Instruction Sheet 240164 the introduction of Kit 231738K to replace 3 Pole Contactor with 4 Pole Contactor.

Suitable for the following models:

E32D, E33D.
E32SUB.
E47, PC8140E.

Heating Contactor E32D

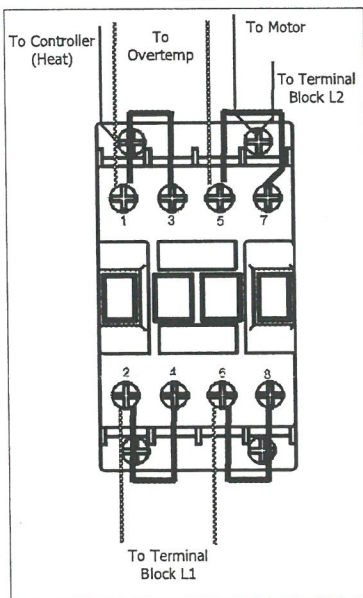
NOTE: Ensure that the supplied loop wires are connected as shown for the new 4 pole connector:-

Heating Contactor E32SUBC3/C4 (3P + N + E)

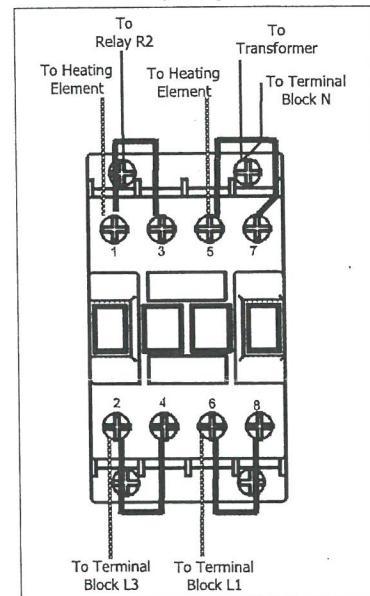
NOTE: The supplied loop wires are not required for these units.
